## **AMENDMENT TO THE DRAWINGS**

## REMARKS

FIG 3

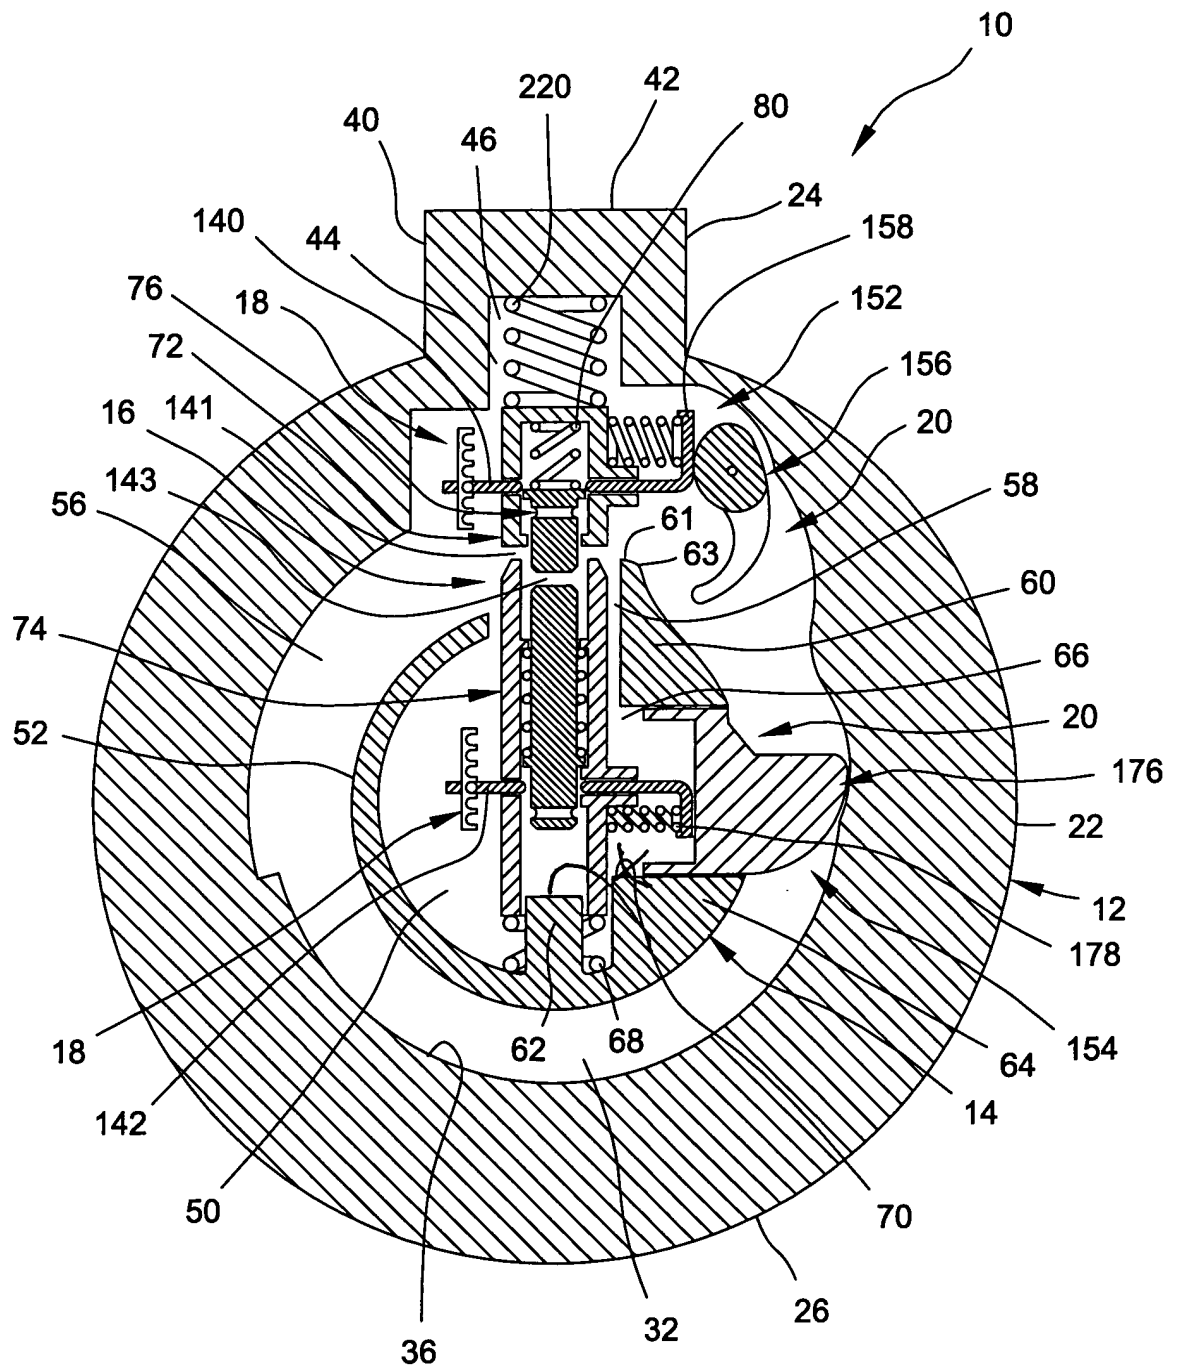
Applicant submits herewith a copy of Figure 3 with proposed amendments in red.

The examiner objected to the specification because surface 216 cannot contact surface 70 as seen in Figure 3. Figure 3 is being amended to redirect the leader line from numeral 70, thereby obviating the objection, and Applicant respectfully requests withdrawal of the related objection.

The numeral 70 is redirected to indicate the correct surface. Applicant also submits a replacement sheet incorporating the proposed amendments.
